# STAFF REPORT

**SUBJECT:** Substantial Conformance Review for the California State University San Marcos Extended Learning Building Parking Structure Screening

**CASE NUMBER:** Substantial Conformance (SC) 19-0003

**CSUSM** | Extended Learning Building  
Parking Garage – West Elevation Screening

## ATTACHMENT E – Proposed Screen Design, Section, & Details

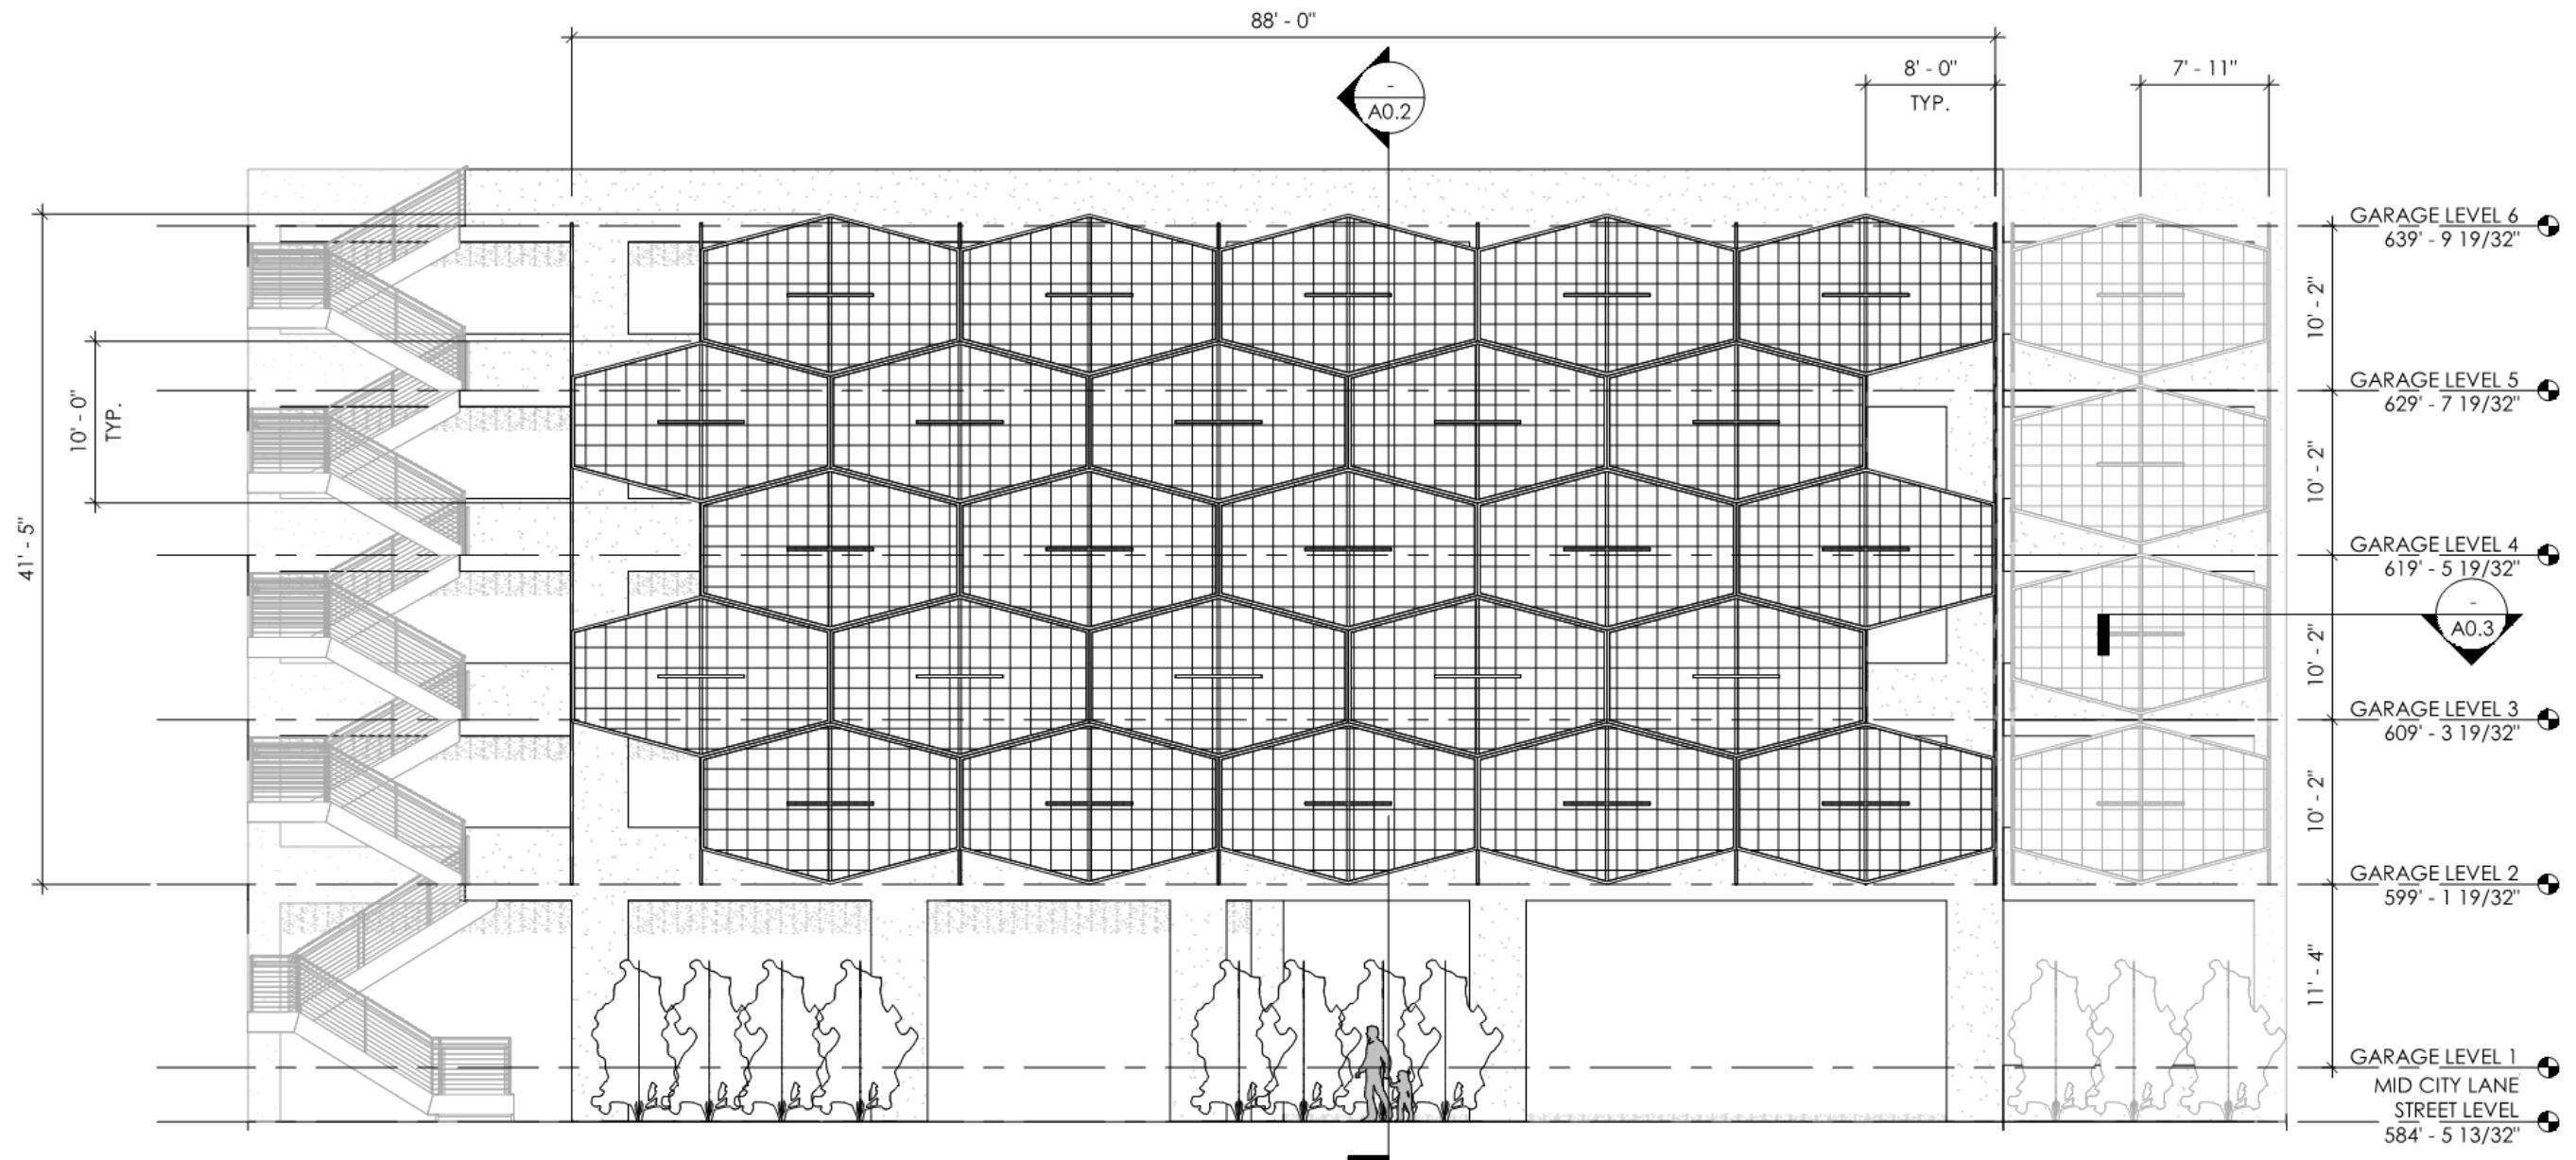
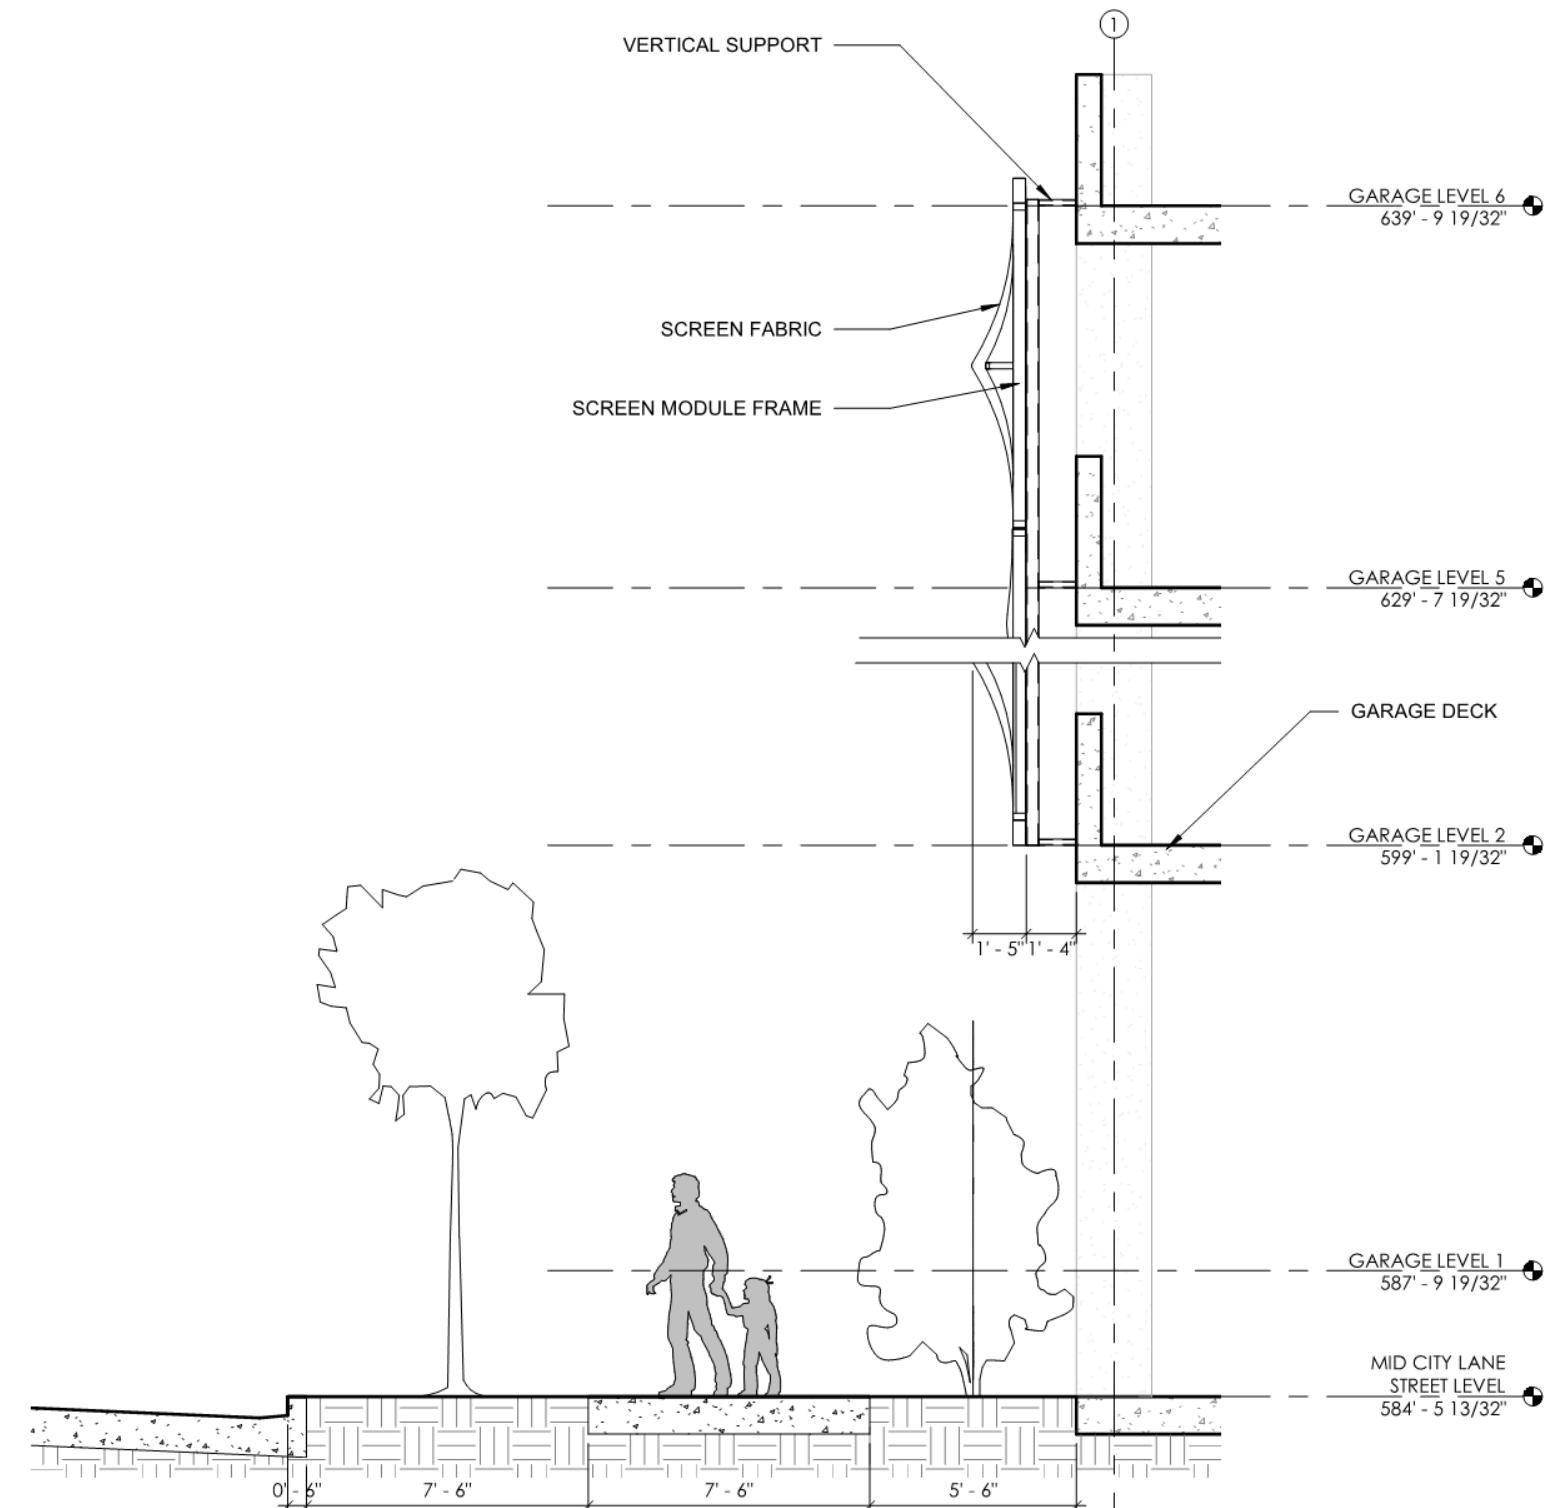
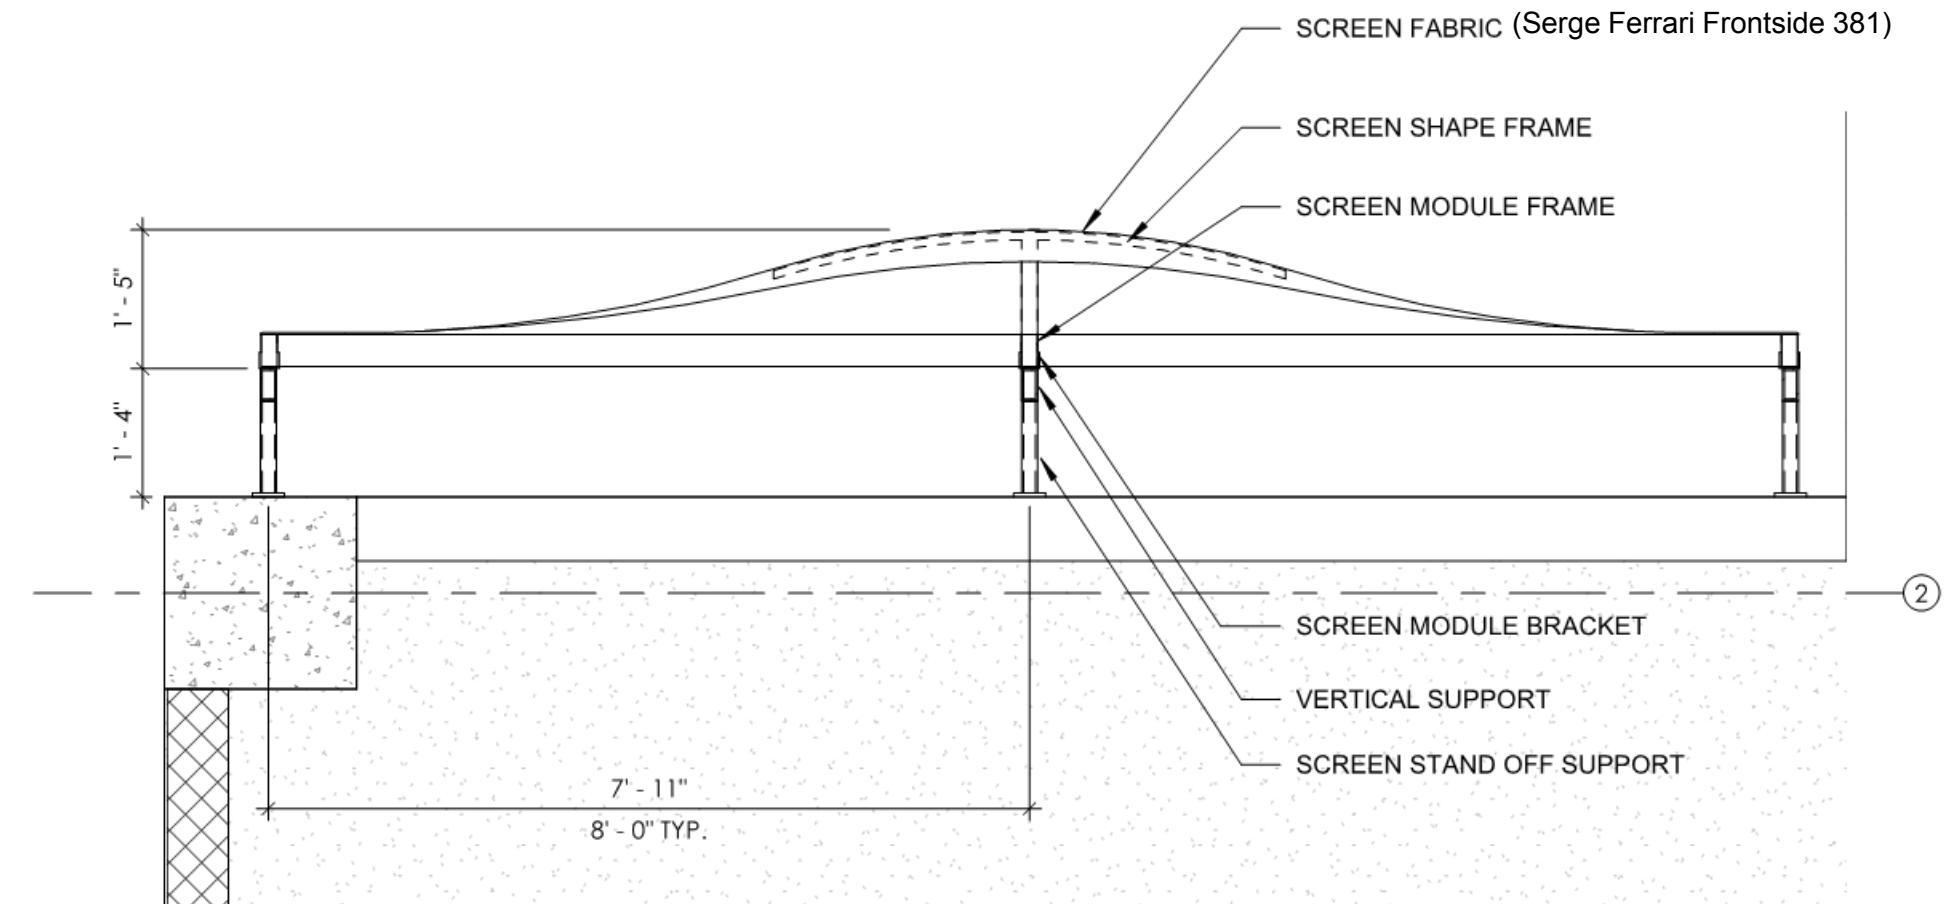
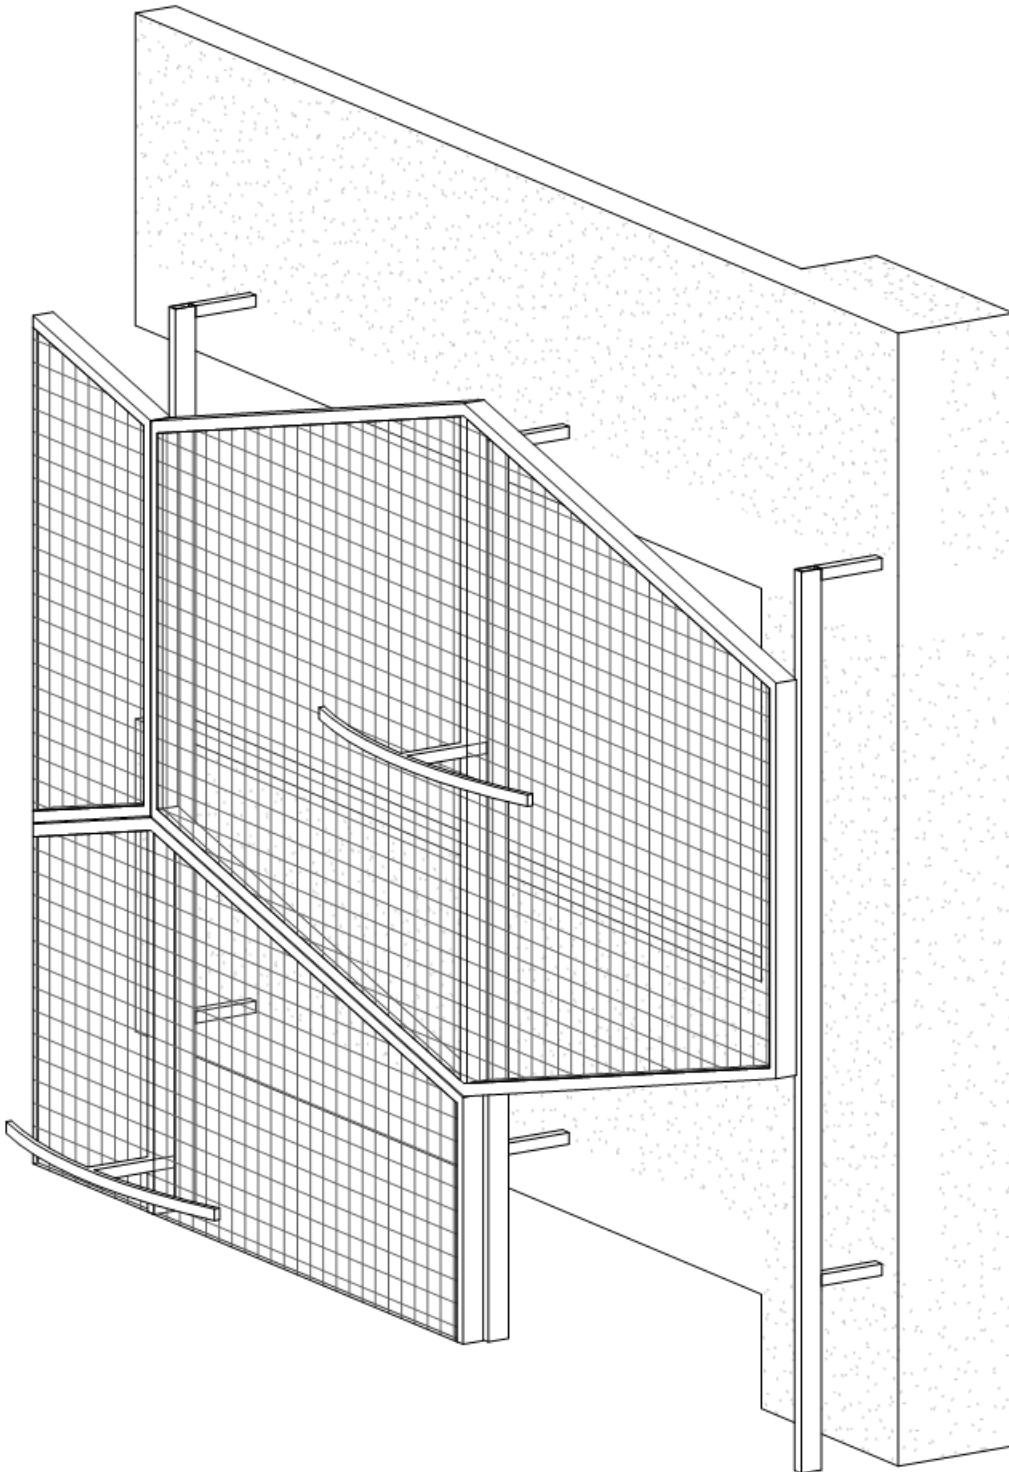
Since the approval of CUP 17-0005, the applicant has proposed a different design that could be replicated on other future parking structures in the UDSP area. The proposed modified screening system is comprised of twenty-nine three-dimensional hexagonal aluminum frames that use a highly tensioned polyester micro-mesh. These screens achieve the primary goal of screening ramps, parking decks, and parked vehicles while creating an interesting and dynamic articulated vertical plane that will change throughout the day as the shadows from the adjacent panels track with the sun’s movement through the San Marcos sky. Two neutral-toned finishes are proposed for the screens. This architectural screening system would extend horizontally across approximately 104-feet and nearly 42-feet vertically. The screen framing cantilevers beyond the parking structure between 1'-6" and 3'-0", which will provide visual interest along the street. Please see Attachment E - proposed parking structure screening system elevations.

The framework is constructed of extruded aluminum elements that are high-strength, will not rust, and have extremely high corrosion resistance. The polyester micro-mesh is fabricated to lock into the aluminum channel framework and has a 10-year warranty. It can be repaired/patched if cut or damaged or, if repair is not acceptable, the mesh may be easily replaced.

WHEREAS, the applicant is requesting to modify the design of the permanent screening mechanism on the west end of the parking structure with a design comprised of twenty-nine three-

dimensional hexagonal aluminum frames that use a highly tensioned polyester micro-mesh; and

- E. The parking structure screening shall be maintained free of wear, tear, and/or fraying. Damaged screening shall be repaired and/or replaced upon notification by the City or property owner.
